CITY OF ALBUQUERQUE

RE: Lot 14 Block 7 Unit 18 SAD 228 6515 Papagayo Rd. NW Grading and Drainage Plan Engineers Stamp Date 10/23/2023 (D10D003L18)

DRAINAGE AND TRANSPORTATION INFORMATION SHEET (REV 6/2018)

C1

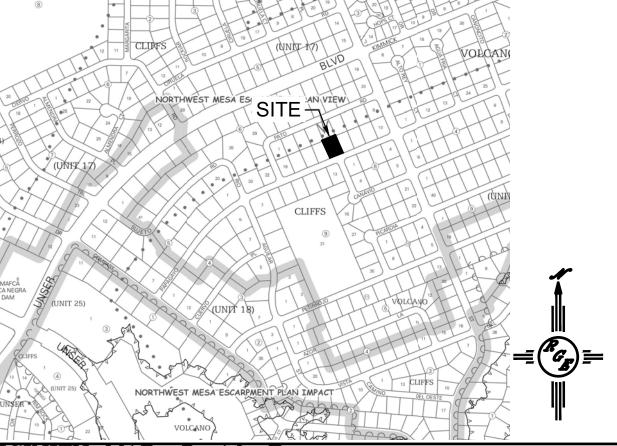
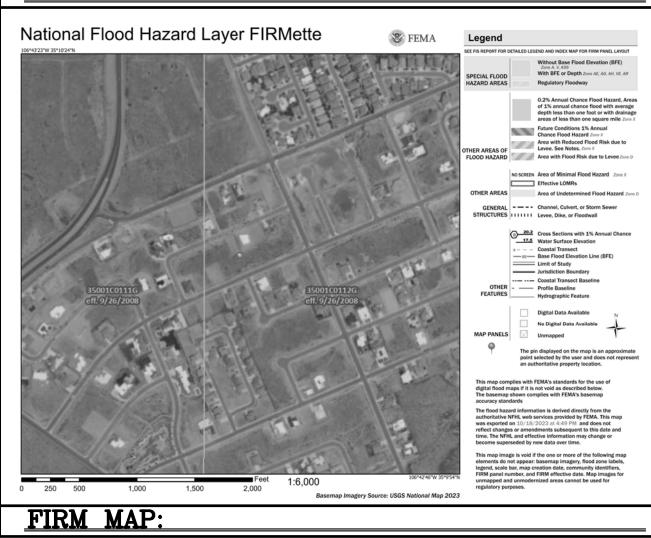
Based upon the information provided in your submittal received 10/23/2023, this plan is approved for Grading Permit.

Prior to Building permit approval a Pad Certification will be required, provided by the Engineer or a registered Land Surveyor.

Advise the owner contractor not to use dirt as a ramp to climb the curb, use lumber or crusher fines for this purpose.

Reiterate to the Owner/Contractor that a separate permit for a garden/retaining wall must be obtained with the approved G&D plan and Pad Certification. Also, if a swimming pool is to be placed the grading and drainage plan will change and will need to be resubmitted.

Prior to Certificate of Occupancy release, Engineer Certification per the DPM checklist is required.
